V2500-A1/A5 SERIES PROPULSION SYSTEMS SERVICE BULLETIN

V2500-ENG-72-0553
Transmittal - Page 1 of 2

ENGINE – INTRODUCTION OF A NEW TRIM BALANCE PROBE AND DELETION OF RELATED POWERPLANT
VOLTAGE DIVIDER HARNESS ASSEMBLY

Removal of the Speed Probe Harness and Voltage Divider Harness Assembly
Figure 1 (Sheet 1 of 3)

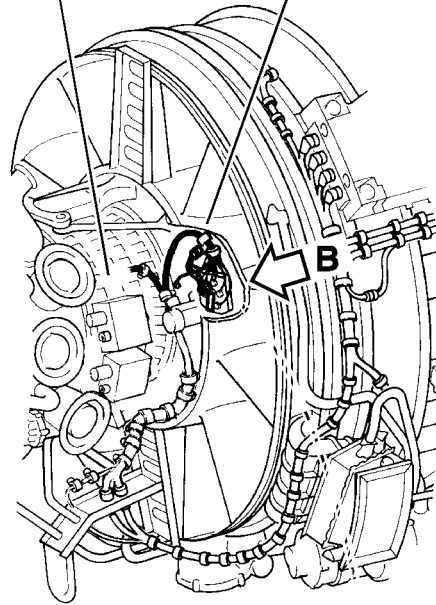
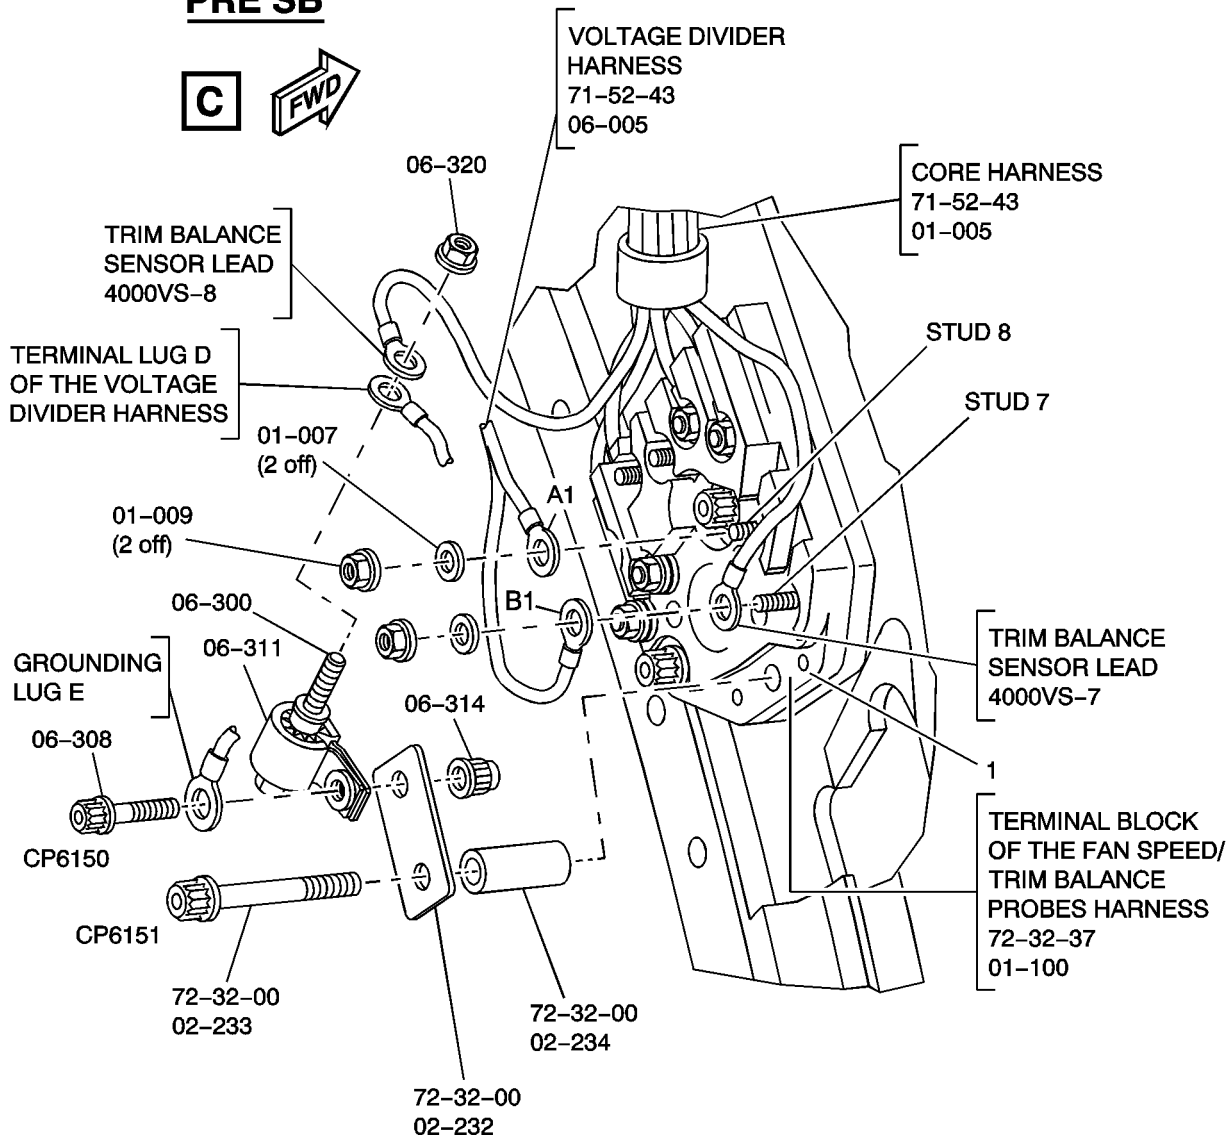
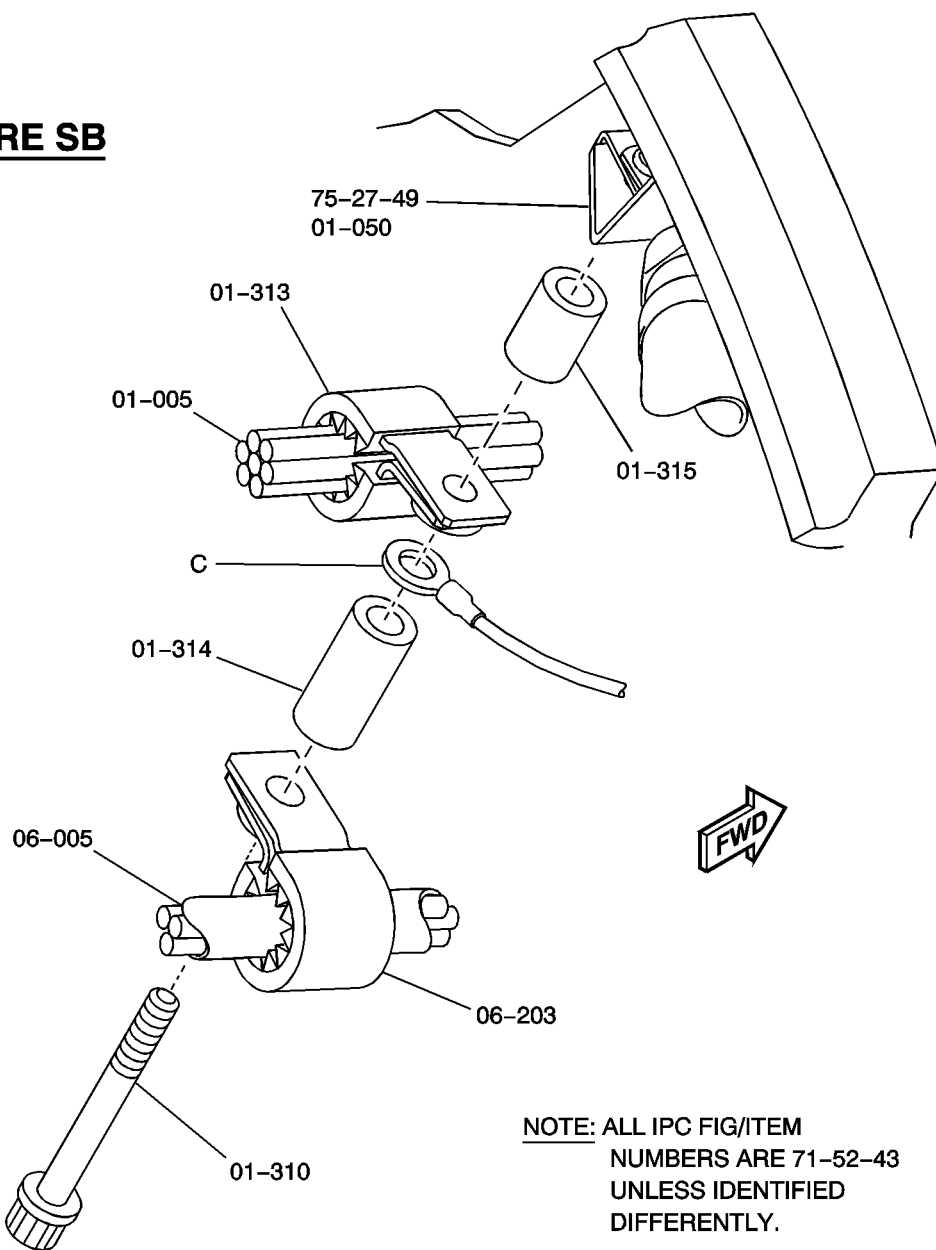
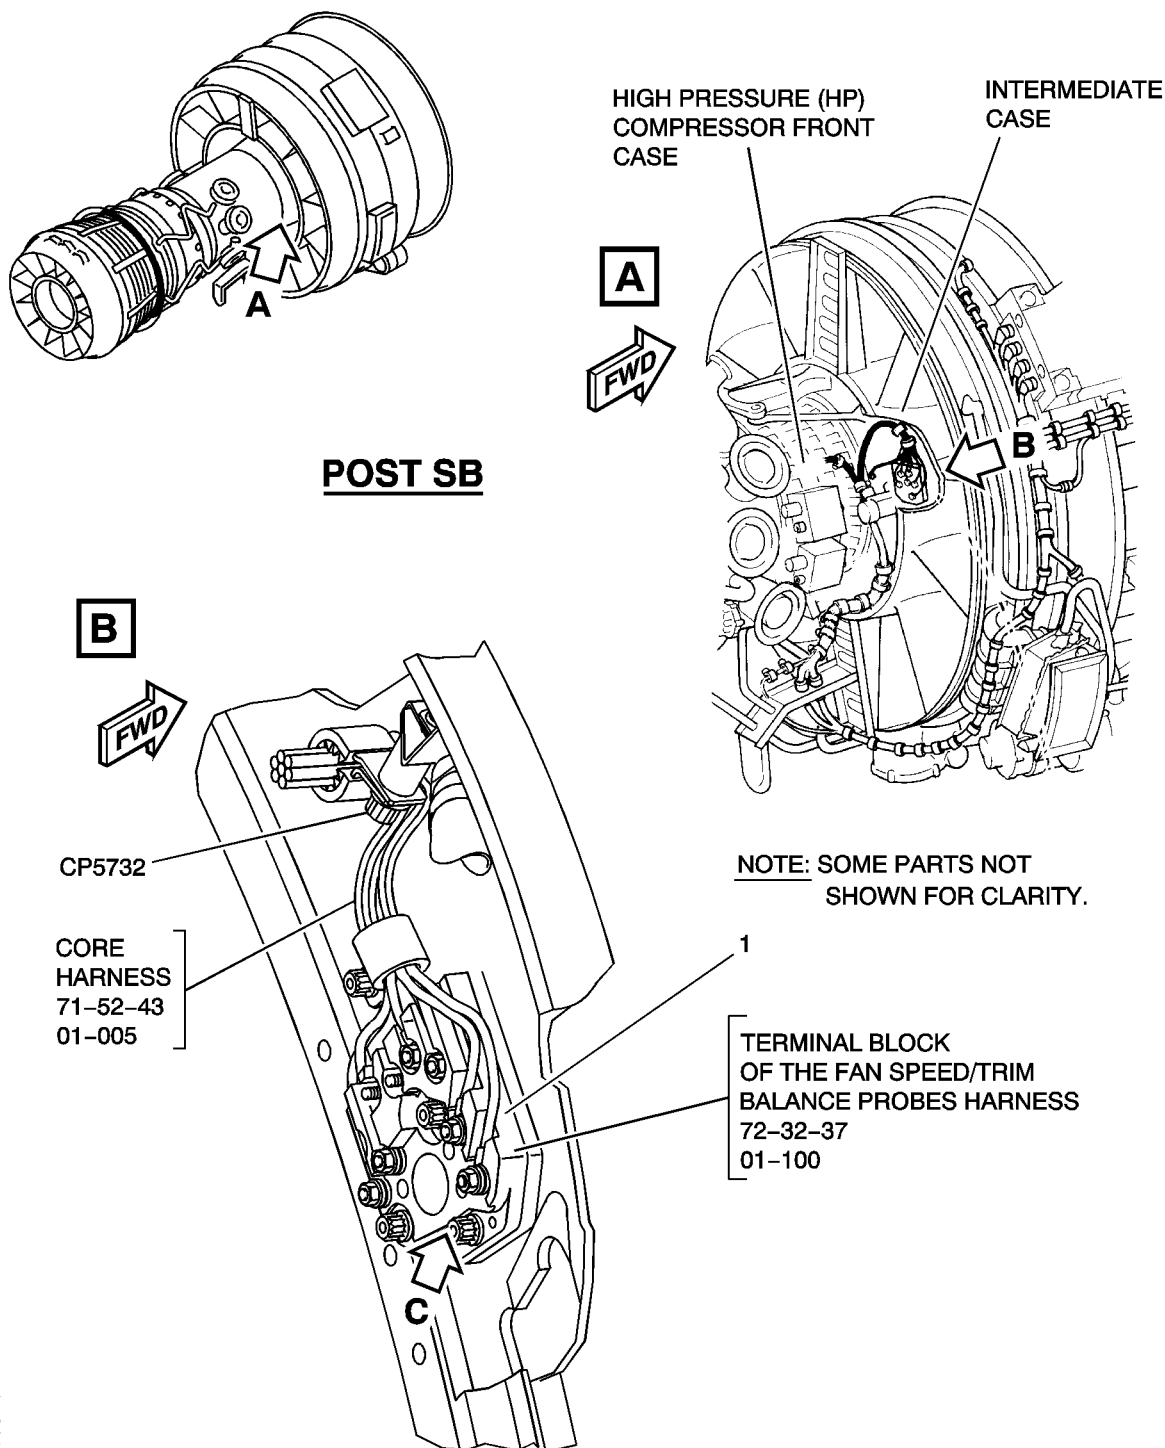
- (7) Remove the parts at the clip position CP6150 on the bracket (72-32-00, 02-232) (Refer to Figure 1, Sheets 1 and 2)

- (a) Remove the old nut (71-52-43, 06-320), P/N AS27831 that attaches the terminal lug D of the voltage divider harness assembly (71-52-43, 06-005) and the trim balance sensor lead 4000VS-8 of the fan speed/trim balance probes harness (72-32-37, 01-100) to the bolt assembly (71-52-43, 06-300).

- (b) Remove the terminal lug D of the voltage divider harness assembly (71-52-43, 06-005) and the trim balance sensor lead 4000VS-8 of the fan speed/trim balance probes harness (72-32-37, 01-100) from the bolt assembly (71-52-43, 06-300).

- (c) Remove the old bolt (71-52-43, 06-308), P/N 4W0344 and the old nut (71-52-43, 06-314), P/N 4W0001 that attach the grounding terminal lug E of the voltage divider harness assembly (71-52-43, 06-005) and the clip (71-52-43, 06-311) to the bracket (72-32-00, 02-232).

- (d) Remove the old clip (71-52-43, 06-311), P/N AS62203 with the old bolt assembly (71-52-43, 06-300), P/N 6A8967.
- (8) Remove the parts at the changed clip position CP5732 on the bracket (75-27-49, 01-050) (Refer to Figure 1, Sheets 1 and 3)

- (a) Remove the old bolt (71-52-43, 01-310), P/N AS21425, the old spacer (71-52-43, 01-314), P/N UP10480 and the spacer (71-52-43, 01-315) that attach the clip (71-52-43, 06-203), the grounding terminal lug C of the voltage divider harness assembly (71-52-43, 06-005) and the clip (71-52-43, 01-313) to the bracket (75-27-49, 01-050).

- (b) Remove the old voltage divider harness assembly (71-52-43, 06-005), P/N 6A8933.
 - (c) Remove the old clip (71-52-43, 06-203), P/N AS62205.
- (9) Install the parts at the changed clip position CP5732 to the bracket (75-27-49, 01-050) (Refer to Figure 2, Sheets 1 and 3)

- (11) Disconnect the voltage divider harness assembly (71-52-43, 06-005) and the core harness (71-52-43, 01-005) from the terminal block (1) of the fan speed/trim balance probes harness (72-32-37, 01-100) (Refer to Figure 1, Sheets 1 and 2)

- (a) Remove the nut (71-52-43, 01-009) and the washer (71-52-43, 01-007) that attach the terminal lug A1 of the voltage divider harness assembly (71-52-43, 06-005) to the stud 8 of the terminal block (1).

- (b) Remove the terminal lug A1 of the voltage divider harness assembly (71-52-43, 06-005) from the stud 8 of the terminal block (1).
 - (c) Remove the nut (71-52-43, 01-009) and the washer (71-52-43, 01-007) that attach the terminal lug B1 of the voltage divider harness assembly (71-52-43, 06-005) and the trim balance sensor lead 4000VS-7 of the core harness (71-51-43, 01-005) from the stud 7 of the terminal block (1).

- (d) Remove the terminal lug B1 of the voltage divider harness assembly (71-52-43, 06-005) from the stud 7 of the terminal block (1).

Installation of the Speed Probe Harness Assembly
Figure 2 (Sheet 1 of 3)

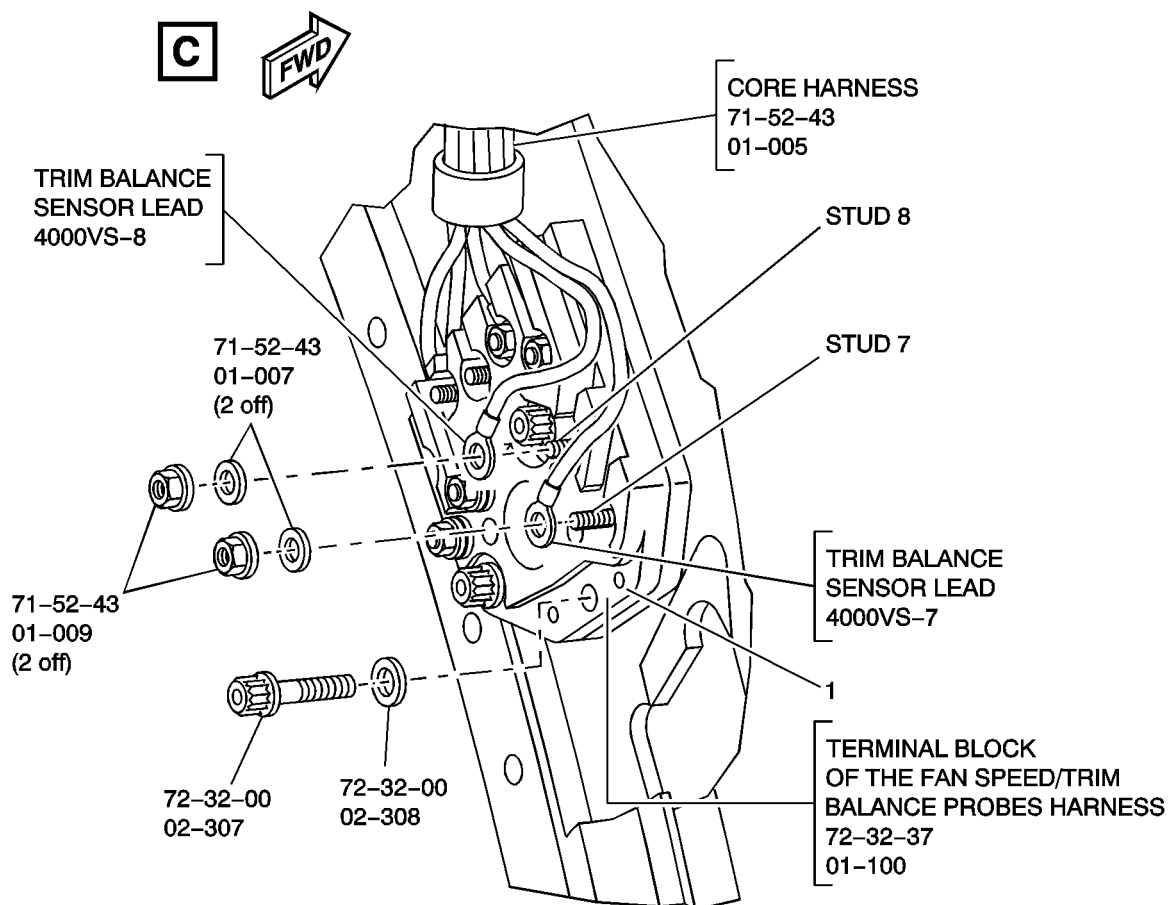
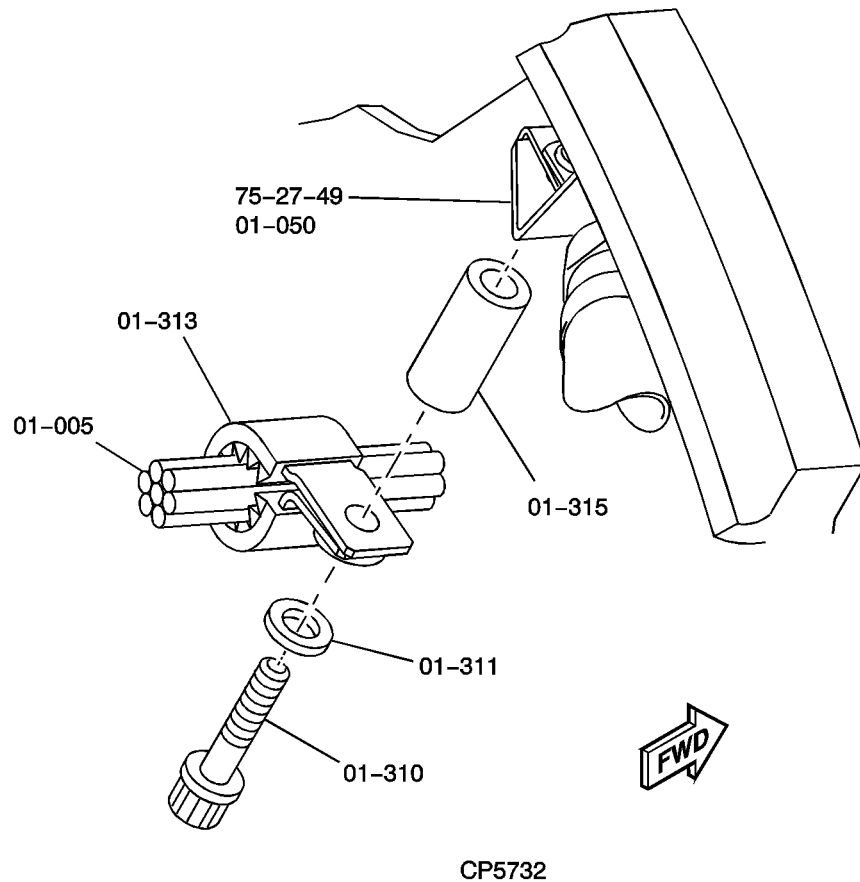
- (a) Install the new bolt (71-52-43, 01-310), P/N 4W0112, the new washer (71-52-43, 01-311), P/N 5W1086 and the spacer (71-52-43, 01-315) that attach the clip (71-52-43, 01-313) with the core harness (71-52-43, 01-005) to the bracket (75-27-49, 01-050).

- (b) Torque the bolt (71-52-43, 01-310) to 40 lbf in. (4,5 Nm).
- (10) Remove the parts at the clip position CP6151 from the terminal block (1) of the fan speed/trim balance probe harness (72-32-37, 01-100) (Refer to Figure 1, Sheets 1 and 2 and to Figure 2, Sheets 1 and 2)

- (a) Remove the old bolt (72-32-00, 02-233), P/N AS21030 and the old spacer (72-32-00, 02-234), P/N 5A1909 that attach the old bracket (72-32-00, 02-232), P/N 6A8958 to the terminal block (1).

- (b) Install the new bolt (72-32-00, 02-307), P/N AS21014 and the new washer (72-32-00, 02-308), P/N MS9321-10 that attach the terminal block (1) to the intermediate case.

- (13) Connect the core harness (71-52-43, 01-005) to the terminal block (1) of the fan speed/trim balance probes harness (72-32-37, 01-100) Refer to Figure 2, Sheets 1 and 2)

- (a) Install the trim balance sensor lead 4000VS-8 of the core harness (71-52-43, 01-005) to the stud 8 of the terminal block (1).
 - (b) Install the nut (71-52-43, 01-009) and the washer (71-52-43, 01-007) that attach the trim balance sensor lead 4000VS-8 of the core harness (71-52-43, 01-005) to the stud 8 of the terminal block (1).

- (i) Torque the bolt (72-32-00, 02-307) to between 85 and 105 lbf in. (10 and 12 Nm).

- (i) Torque the nut (71-52-43, 01-009) to between 10 and 14 lbf in. (1,13 and 1,58 Nm).
 - (c) Install the nut (71-52-43, 01-009) and the washer (71-52-43, 01-007) that attach the trim balance sensor lead 4000VS-7 of the core harness (71-52-43, 01-005) to the stud 7 of the terminal block (1).

- (i) Torque the nut (71-52-43, 01-009) to between 10 and 14 lbf in. (1,13 and 1,58 Nm).
- (14) Make sure that the work are is clean and clear of tools, equipment and other unwanted materials.
